FAQ 20-01: Nine Mile Point Scram – Tentatively Approved

Plant: Nine Mile Point Unit 1

Performance Indicator: Unplanned Scrams with Complications

NMP1 Scram 9/6/17 Lo Reactor Water Level

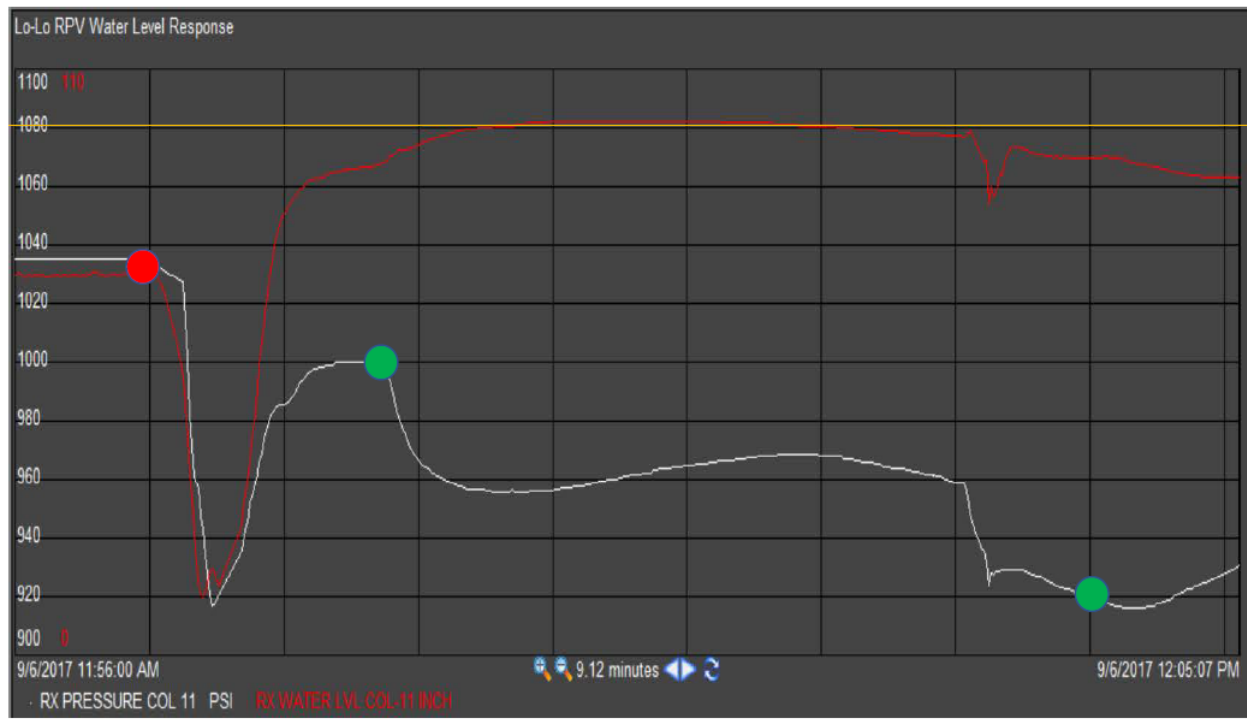
the scram response. As shown on Attachment 1, RPV Water Level and RPV Pressure responded as expected to the scram and no further equipment issues occurred during the scram response that cause complications required additional operator action to address. The entire transient spanned from the initiating event to the time the ECs were placed into operation.

1005 psig which is well below the entry condition of 1080 psig. No other EOP entry conditions were met during the scram response. Therefore, the answer to this statement is "No."
